TRANSMITTAL No. 15-0321-001-0009
PROJECT: 15-0321-001 St. Laurent Lagoon Assessment

SUBJECT: Notice of Alteration - Sandy Bar Road Wastewater Treatment Facility (Revised) / Application for Wastewater Treatment Facility Classification Form

RE: St. Laurent Lagoon Assessment
Notice of Alteration - Sandy Bar Road Wastewater Treatment Facility

FIGURE 01

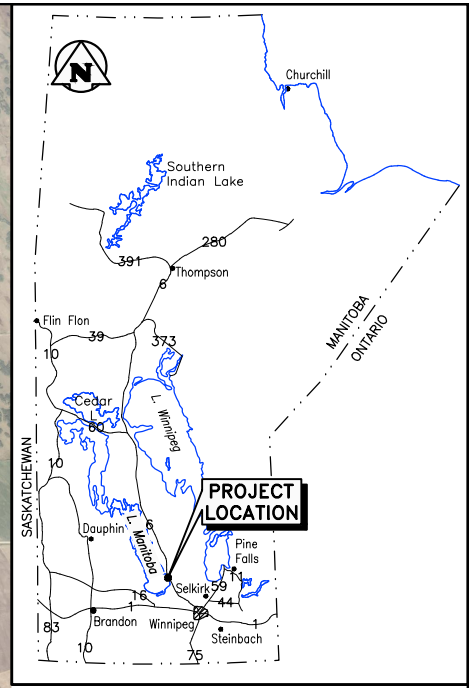
The new holding cell can be accomplished by installing a new interconnecting valve on the secondary cell of the lagoon and converting the culvert through the flood protection dike to a valve. The location of the new valves (as shown on Figure 1) will be documented and marked within the facility.

In consideration of the long-term use of the facility, Manitoba Housing Authority has proposed a relocation of the access road. Therefore, the existing road will not be repaired, but a new road will be constructed to suitable conditions. The proposed road alignment is shown on Figure 1.
